Draft Frankston Activity Centre Plan

Frankston City Council Officer Submission

28 September 2024

Figure 01: Recommended changes to the proposed catchment area boundary

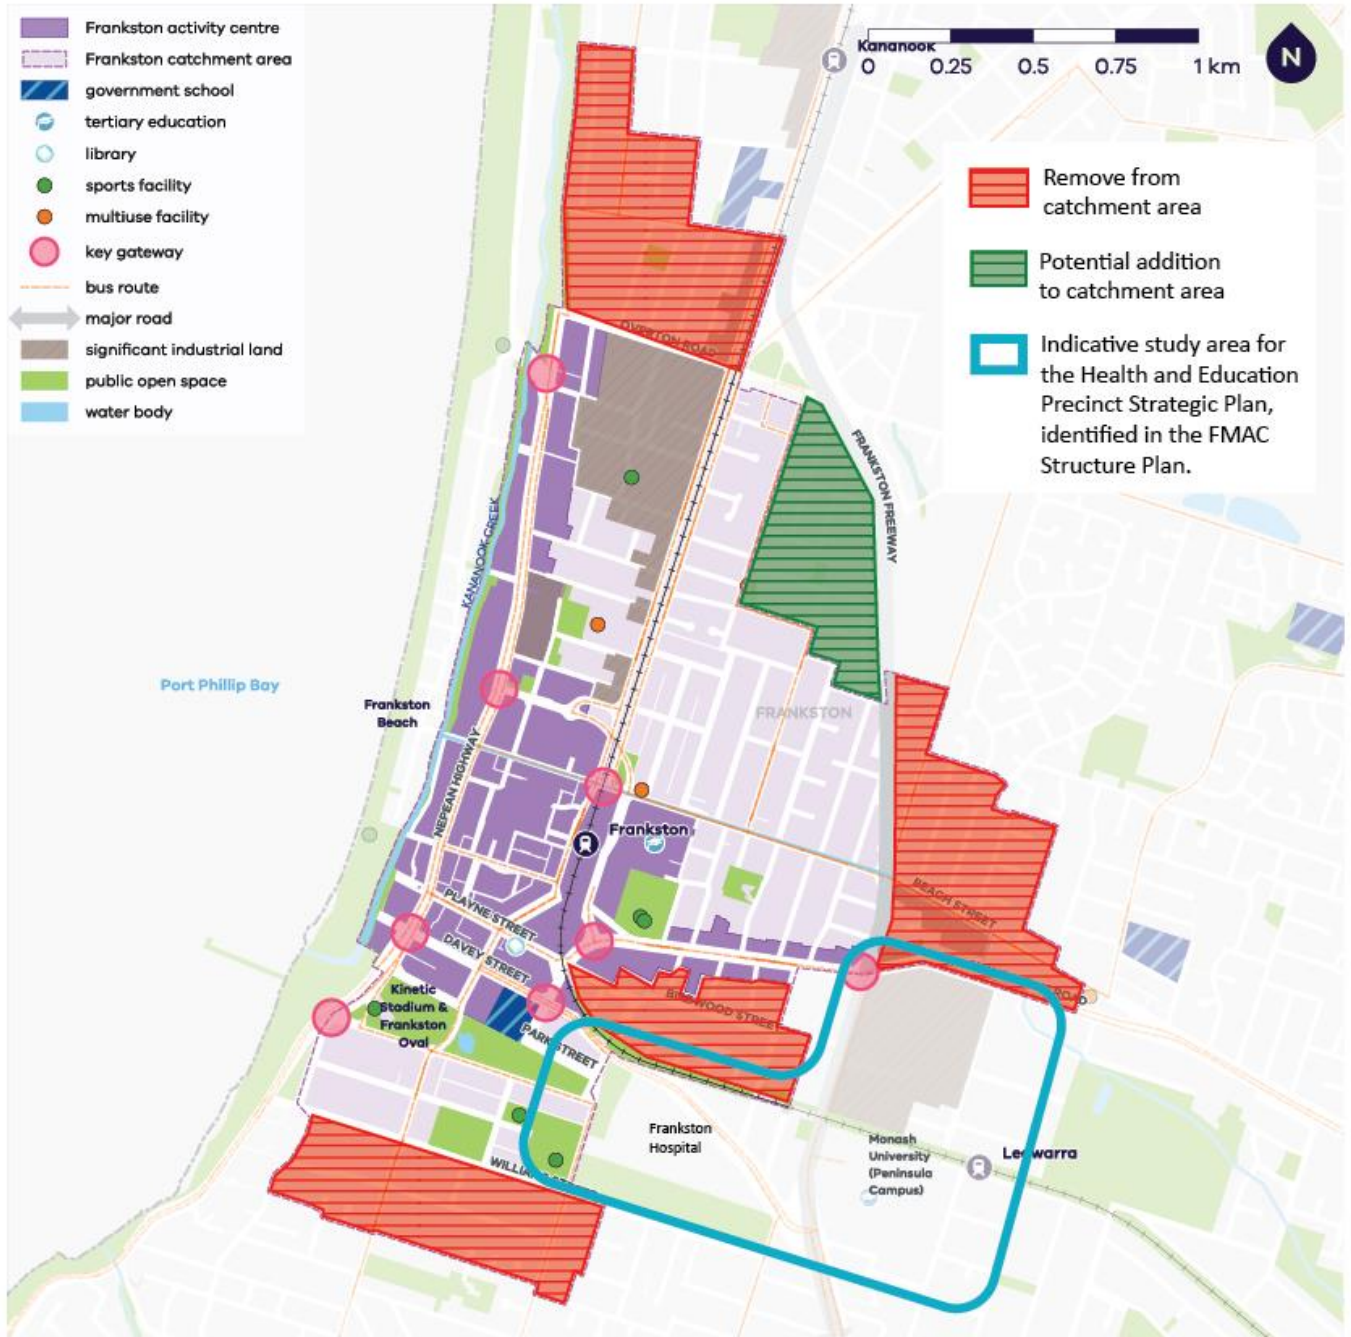
The following areas should be excluded from the catchment area boundary and instead be considered as part of the development of the draft Housing Strategy for the following reasons:

1. **The area north of Overton Road** (north of the FMAC) is currently zoned General Residential Zone (GRZ) and is subject to significant flooding. This area is not considered to be the right location for the intensification identified in the draft Activity Centre Plan as it has a sensitive interface with existing surrounding low-scale residential areas and the preferred maximum building heights south of Overton Road in the FMAC Precinct 5 – Nepean Boulevard are 3 storeys (significantly lower than the proposed 6 storeys for the catchment area). This graduation in height in Precinct 5, was intentional to provide an appropriate transition to the surrounding residential area.

2. **The area south of Williams Street** (south of the FMAC) is of distinct and unique character, predominately due to the area's elevation and views and is adjacent to Frankston South, which is an area of high value character.

3. **The area east of the Frankston Freeway** (east of the FMAC) should be excluded as the Frankston Freeway presents a physical barrier (particularly in terms of being able to walk to the FMAC) and provides a logical boundary to the proposed catchment area. The proposed boundary facilitates planning creep, beyond a logical boundary and will

4. **A future strategic plan for the Frankston Hospital and Monash University Precinct** is referred to in the future work section of the draft Frankston Activity Centre Plan. Frankston City’s largest industry sector is healthcare and social assistance, employing over 11,000 people (since 2021) and adds \$1.08 billion into the economy. With the \$1 billion redevelopment of the Peninsula Health Frankston Hospital (underway), this sector continues to rapidly expand and presents a range of opportunities for primary and allied health businesses for more specialised services.

This area should be excluded from the catchment boundary and be considered as part of the future Health and Education Precinct Plan, which will also consider housing growth and types in the surrounding area.

5. **The area bounded by Precinct 6: Cranbourne Road in the FMAC Structure Plan area to the north, the railway line to the south and west and the proposed catchment area boundary to the east.**

This area is included in the indicative study area for the Health and Education Precinct Plan, which includes the Power Centre, Monash University, Leawarra Station, Frankston Hospital and surrounding residential land. Built form controls should not be applied to this area prior to the strategic work being undertaken for the Health and Education Precinct, which will consider land use in these mixed use areas that support the anchor uses. It is noted that land use considerations are outside the scope of the catchment areas in the draft Activity Centre Plan.

The following area should be considered for inclusion in the catchment area boundary:

6. **The area bound by the Frankston Freeway to the north and east, Orwil Street to the west and Cricklewood Avenue, Stanley Street and Francis Street to the south.** This area is not subject to significant flooding and does not have the same sensitive residential interface as the area north of Overton Road, due to its hard boundary with the Frankston Freeway. This area includes a local Activity Centre on the corner of Orwil and Fairway Streets and officers submit that it could be included as an alternative to achieve targets, to the areas identified for removal above. It is important to note that these areas will be further considered through the development of the draft Housing Strategy.

This area should be excluded from the catchment boundary and the appropriate level of growth for this area be determined through the development of Council's draft Housing Strategy, which will also consider flooding and take into account Melbourne Water data that is currently unavailable.

This area should be excluded from the catchment boundary and addressed through the development of Council's draft Housing Strategy which will consider neighbourhood character, a matter that is outside of the scope of the draft Activity Centre Plan.

This area should be excluded from the catchment boundary and the appropriate level of growth for this area to be determined through the development of Council’s draft Housing Strategy.

Figure 04: 6 storey development within 340m of Highett Railway Station

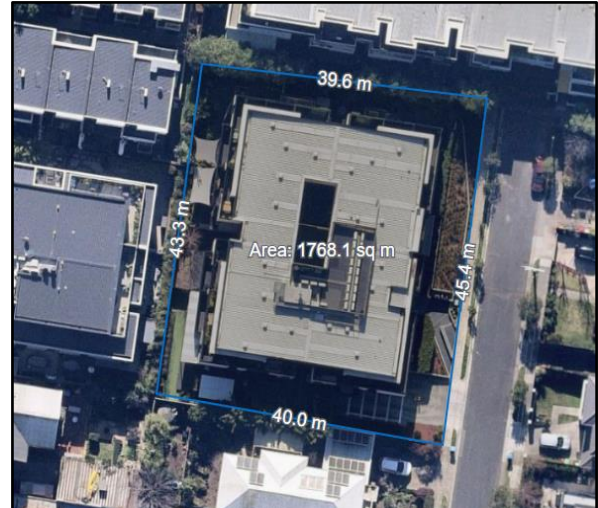
The FMAC Structure Plan specifies preferred maximum height limits for the 6 precincts, which range from 3-16 storeys. The building heights in Precinct 5 – Nepean Boulevard and Precinct 6 – Cranbourne Road have been intentionally drafted to step down to adjacent low scale residential areas, providing an appropriate transition. In Precinct 5, north of Rosella Street and south of Overton Road, the preferred maximum height steps down to 12m (3 storeys). In Precinct 6, the majority of Cranbourne Road has a preferred maximum height of 16m (4 storeys). The proposed 6 storey building heights in the catchment area is problematic adjacent to the areas where heights lower than 6 storeys are specified in the FMAC Structure Plan and ACZ1.

Further, the contrast of 6 storey buildings next to 3 storey buildings and single storey dwellings (where sites may never consolidate or re-develop) within the catchment area itself is also concerning. The current lot configuration in the catchment area is varied, with many single residential dwellings on a lot and many unit developments. Significant lot consolidation will be required in order to achieve development of 6 storeys and it is unlikely that all lots will consolidate, even over time. It is important that setbacks are adequate to facilitate landscaping tree planting and mitigate the effects of urban heat island effect. And that overshadowing is taken into consideration to ensure appropriate access to sunlight for both internal and external amenity.

The proposed 3-6 storey height limit for the catchment area should be:

- 1. Retained** for the 'Ebdale Precinct' part of the catchment area. 6 storeys adjacent to the 8-storey preferred maximum building height specified along the eastern side of Nepean Highway in Precinct 5, is appropriate, and this area has a hard edge to the railway line.

2. **Retained** for the area east of Dandenong Road East, west of the Frankston Freeway and north of Beach Street.
3. **Reduced** for the remainder of the catchment area to 3-4 storeys. This will ensure heights in the catchment area are no higher than those within the FMAC, and will not compromise the considered delineation and graduation of height between the FMAC and the surrounding areas. This will also address the issue of stepping down of built form adjacent to existing low-scale residential areas (e.g. south of William Street).
